CULLEN VALLEY MINE

SITE WATER MANAGEMENT PLAN

**MISCELLANEOUS MANAGEMENT PLANS
Cullen Valley Mine - DA-200-5-2003**

Cullen Valley Management Plans – April 2022 Department Review

FIGURE 3

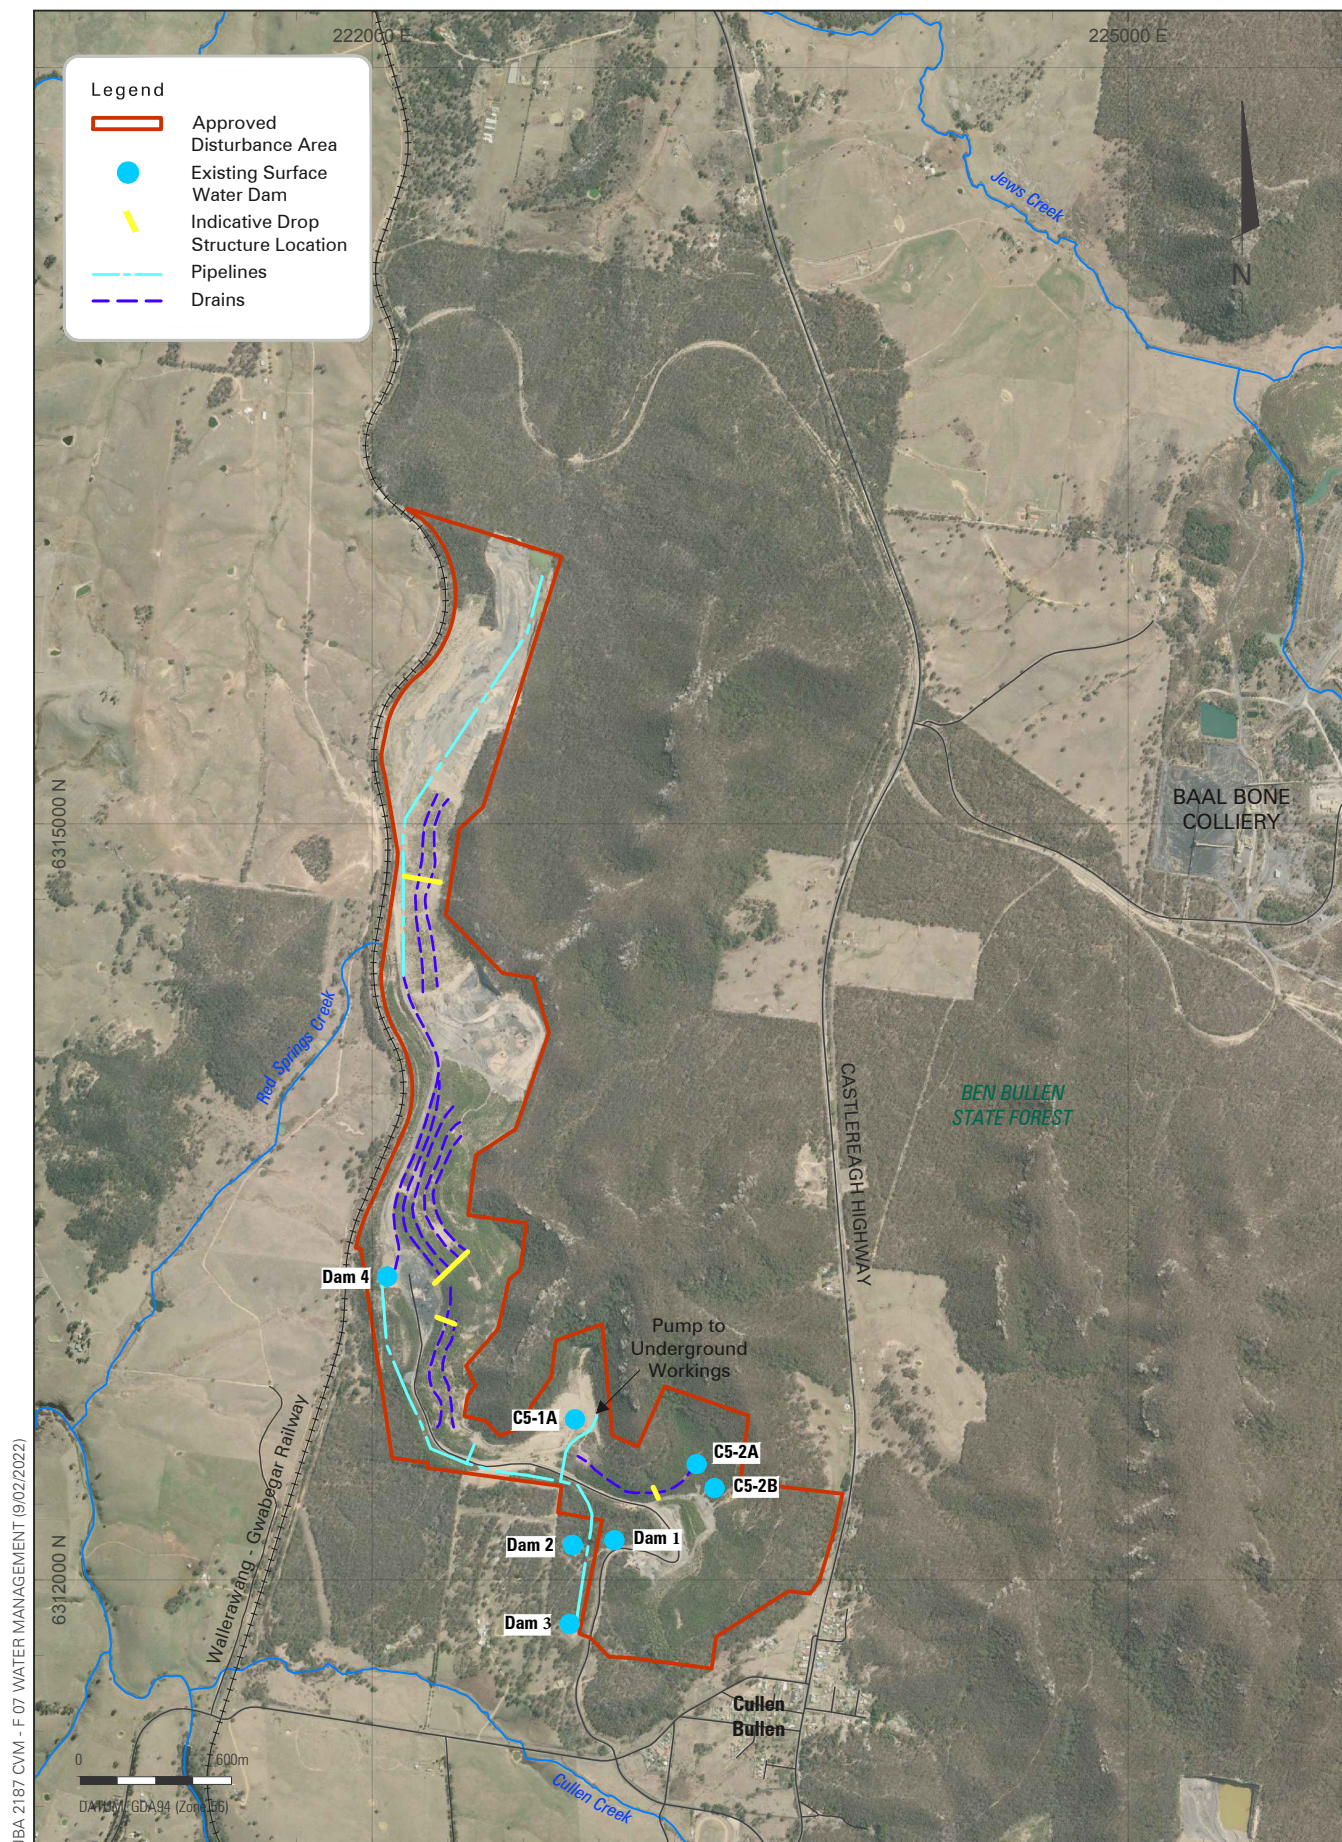
Section 2.3 of the Site Water Management Plan discusses dirty water flow across the mine site. Reference is made to the capacities of sediment dams 1 through to 4 and that 'Dam 1' is sized to contain runoff from a 1 in 10 year, 72-hour storm event (or 171 mm of rain). Little context is provided for these figures - i.e. is this capacity for the sub-catchment reporting to Dam 1 and what about the balance of the site including 'Dam 4'?

need to ensure that sediment retention basins (in an environment like Cullen Valley Mine with 'Type F or D' soils) can hold a 95%, 5-day rainfall event (56.4 mm in the Lithgow district) and are pumped down within a 5-day period to restore dam capacities. The EPA notes that this document was not referenced in the preparation of this management plan.

The Site Water Management Plan contains little detail on how the 4 sediment dams are to be monitored with regard to maintaining capacities after rainfall events (section 2.3.2 states simply that '*Dam levels are to be checked on a monthly basis or after rainfall events...*' and that '*excess water is to be transferred ...*'). The EPA would recommend that techniques such as depth gauge boards could be used to indicate the amount of freeboard available at a dam and how much water needs to be removed to restore dam capacity.

<ul style="list-style-type: none"> - 2.2.3 – stronger commitment to maintain freeboard to ensure the required rainfall events are captured. 	<ul style="list-style-type: none"> - Section 2.3.2 has been revised and updated to strengthen commitment to maintain adequate freeboard in accordance with Blue Book requirements.
Surface Water Monitoring Program	N	<p>Question</p> <ul style="list-style-type: none"> - Section 3 – there are no procedures or commitments to undertake corrective actions or mitigation measures if the surface water criteria is exceeded. You must include these. 	Sections 3.15 and 3.16 have been included to provide a mechanism for investigation and/or corrective action in the event the surface water criteria/trigger level is exceeded.
Fire Management Plan	Yes	<p>Notes.</p> <p>The Plan could expand more on how it's suitably equipped to deal with fires, however, RFS is satisfied with Plan.</p> <p>Combustion issue is discussed – is being managed with RR.</p>	Noted.
